SERVICE BULLETIN

DATE: August 31, 2005 Service Bulletin No. 548A
(Supersedes Service Bulletin No. 548)

SUBJECT: Diaphragm-Type Fuel Pump Inspection/Replacement

Figure 1

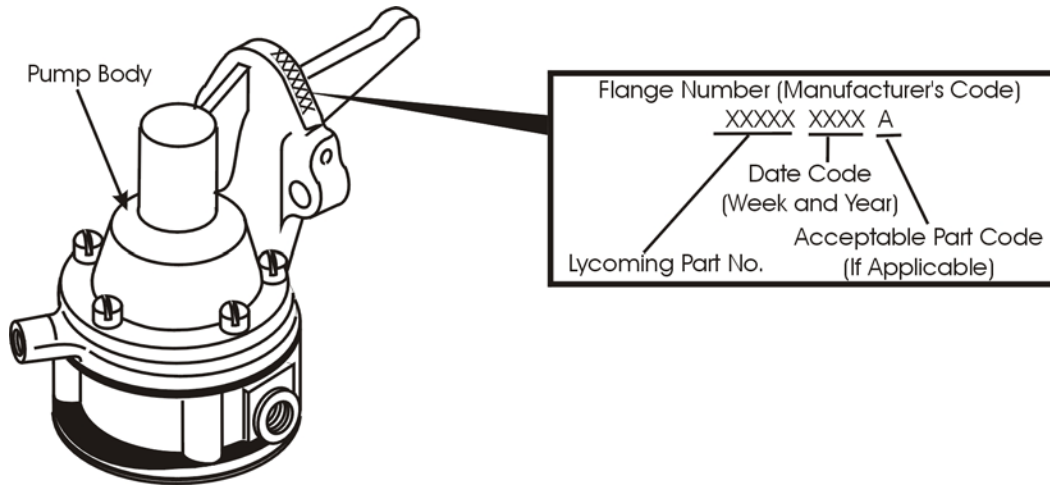
To identify affected pumps, check the manufacturer's code scribed on the flange of the pump (See Figure 1). If the first five digits are 15399, 15472, 15473, or 16335, and the 6th through 9th digits are 0700, 0800, 1100, 1200, 1300, 1400, 1500, 1600, 1800, 2000, 2100, 2200, 2300, 2400, 2800, 2900, 3000, 3100, 3200, 3300, 3400, 3500, 3600, 3700, 3800, 3900, 4000, 4100, 4200, 4300, 4400, 4500, 4600, 4700, 4800, 4900, 5000, 5100, 5200, 0101, 0201, 0301 or 0401, the pump is affected and must be replaced.

If the letter "A" is marked as a suffix to the date code, the pump has been brought into conformity and need not be replaced.

If your Lycoming engine has a diaphragm-type fuel pump with Lycoming P/N LW-15399, LW-15472, LW-15473, or LW-16335 installed, and has a date code of 0700 through 0401, the pump must be replaced within the next 100 hours of operation or 180 calendar days from the date of this Service Bulletin, whichever occurs first.
